NORTH FALLS

Offshore Wind Farm

Supporting Information on Offshore Additional Mitigation

Document Reference:	9.55
Volume:	9
Date:	April 2025
Revision:	0

Figure 2-2. Typical suction bucket cross section (jacket and mono)

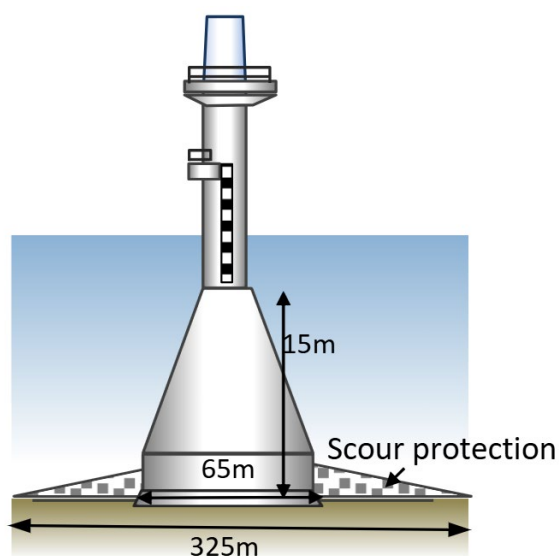
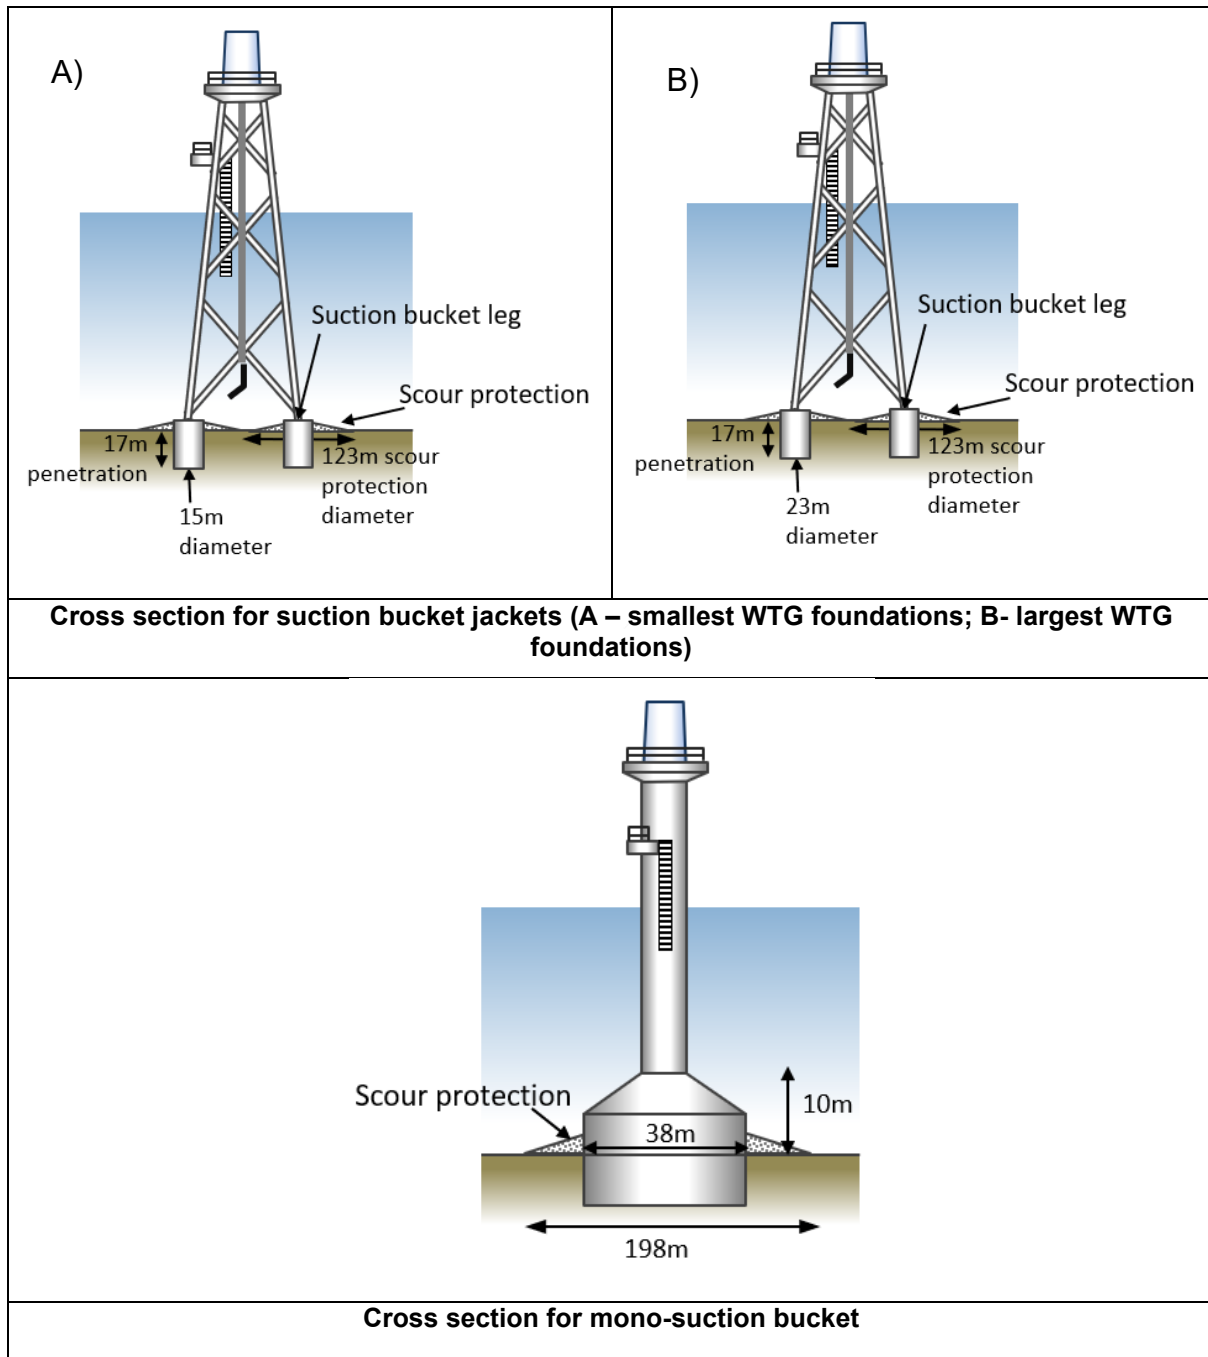
12. When considering foundations cross sections, GBS are significantly larger structures than the remaining options of the North Falls design envelope.
13. As discussed in ES Chapter 5 Project Description **[APP-019]**, GBS usually comprise of a base, a conical, and a cylindrical section (Figure 2-1).

14. As shown in Figure 2-2 below, all remaining foundation options have:

- Smaller diameter of the foundation base;
- Smaller scour protection diameter; and
- Smaller cross-section area within the water column.

Figure 2-3. Distance between order limits and foundations including scour protection.

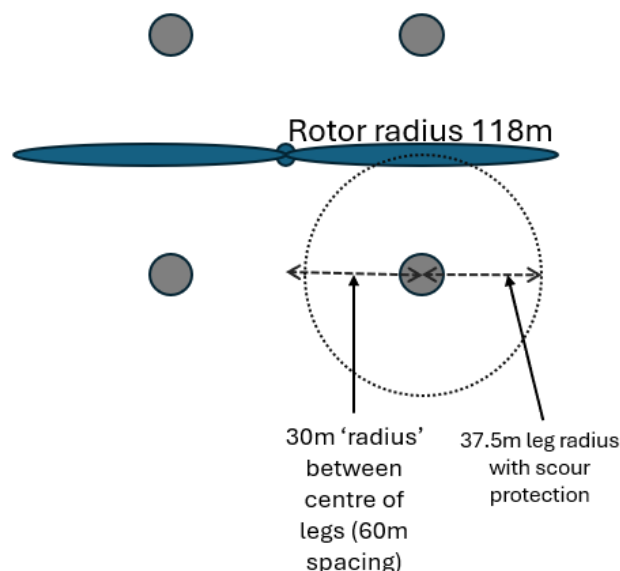
15. Due to the need to ensure there is no over-sail of turbine rotors beyond the order limits, turbine foundations must be set back by a minimum of 50m from the order limits (and therefore a minimum of 50m from the KKE MCZ). This is based on the smallest WTGs (i.e. minimum parameters) using suction bucket jackets as the worst case scenario (118m WTG rotor radius minus the following foundation parameters):
- Suction bucket jacket leg - max scour protection diameter of 75m from centre of suction bucket, a radius of 37.5m; and
 - Leg spacing of 60m (centre of leg to centre of leg at seabed) – thus a radius of 30m from centre of turbine,
16. Therefore, the distance to the MCZ is 118m-37.5-30 (Figure 2-3).

17. This distance aligns with the standard 50m buffer advised by Natural England for Sabellaria reef and while Sabellaria is not a protected feature of the MCZ, this buffer is considered by the Applicant to be conservative for the coarse sediment, sand and mixed sediment features of the KKE MCZ.
18. Due to the minimum spacing required between turbines (1180m in the downwind direction and 944m in the cross wind direction), the majority of WTG will be over 1km from the KKE MCZ, with only a small number of WTG installed within 1km of the KKE MCZ (approximately 3 WTGs).

Figure 2-4. Offshore cable corridor crossing of the Sunk and Trinity Deep Water Routes.

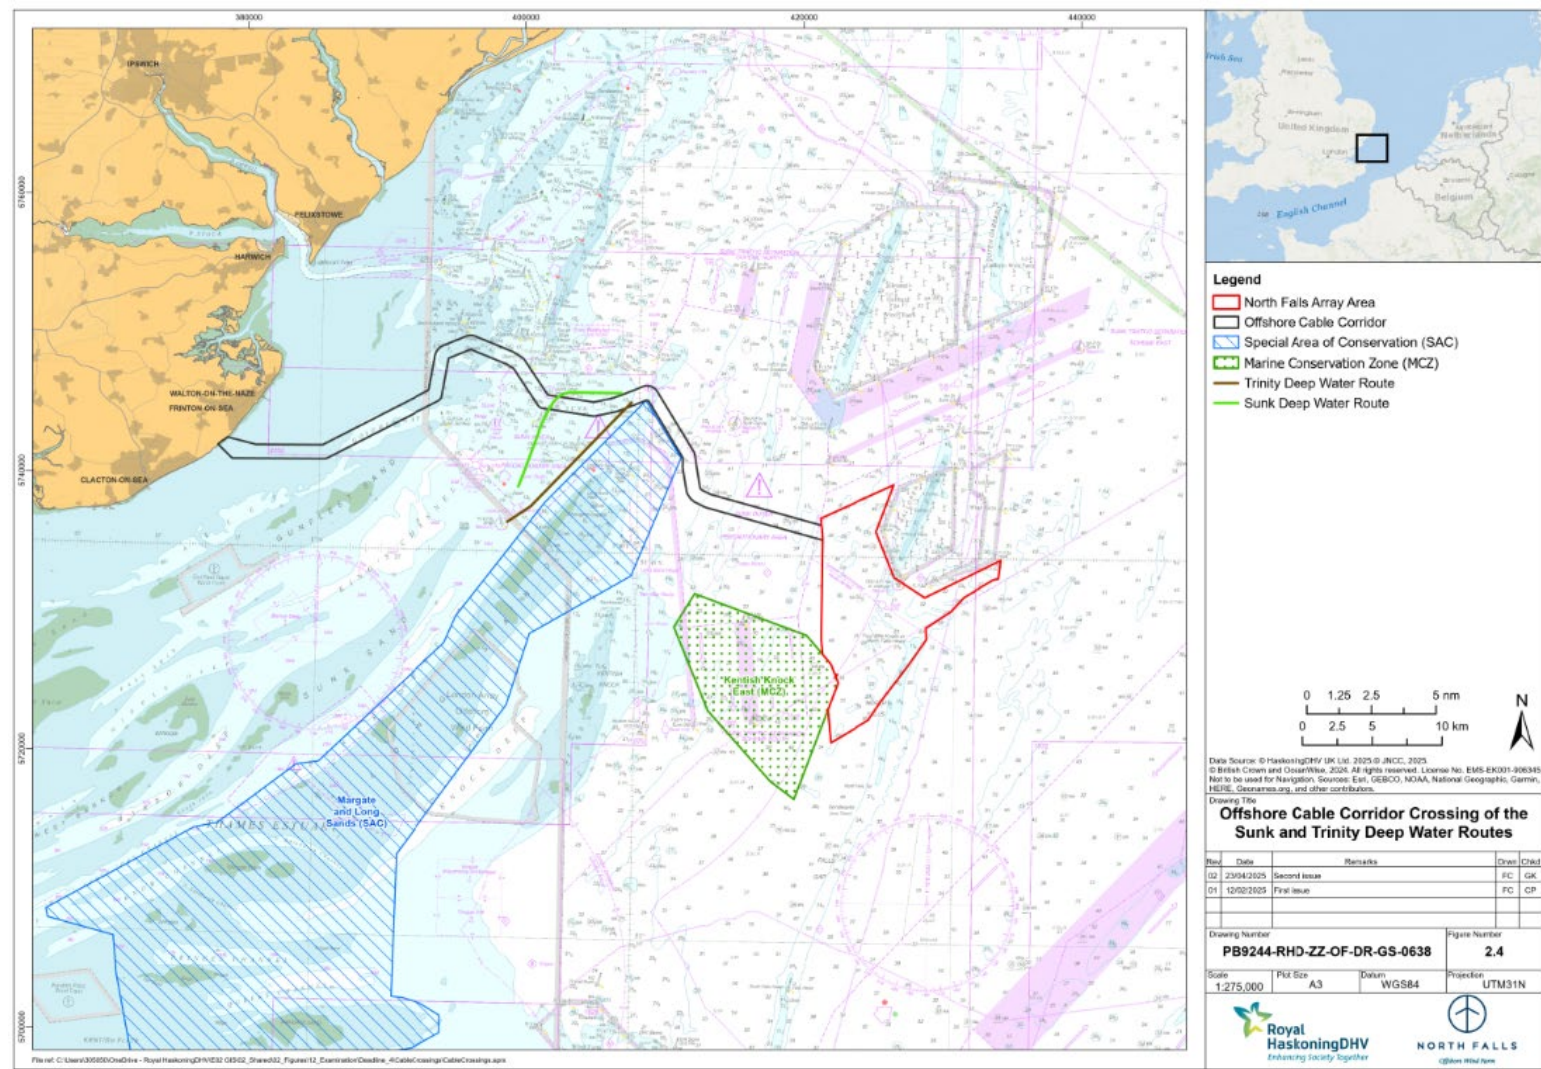
20. Port of London Authority, Harwich Haven Authority and London Gateway have requested the Applicant commit to cables being installed at sufficient depth so as not to preclude future dredging to 22m below chart datum (CD) within the Sunk A and Trinity Deep Water Routes (DWR)s and 19m in the Sunk B (see Deep Water Route Cable Installation Areas (Future Dredging Depths), document reference 9.57), to facilitate potential future vessel keel depths over the life of the Project. This would require additional dredging as the current seabed level is 19-20mCD in these areas.

21. Dredging the DWRs to achieve the requested cable burial depth would result in estimated sediment volumes of 309,628m³ (included in the volumes assessed for the whole offshore cable corridor). The footprint area of works within the DWRs would remain as assessed in the Environmental Statement.

22. Due to the depth of dredging/trenching required to cross the Sunk A and Trinity DWR at a level below 22mCD and the Sunk B DWR at 19m CD, London clay is expected to be present. As a worst case scenario, it is estimated that, of the total sediment above, 304,917 m³ of this could be clay which could result in a seabed footprint of 200,000m² when deposited.
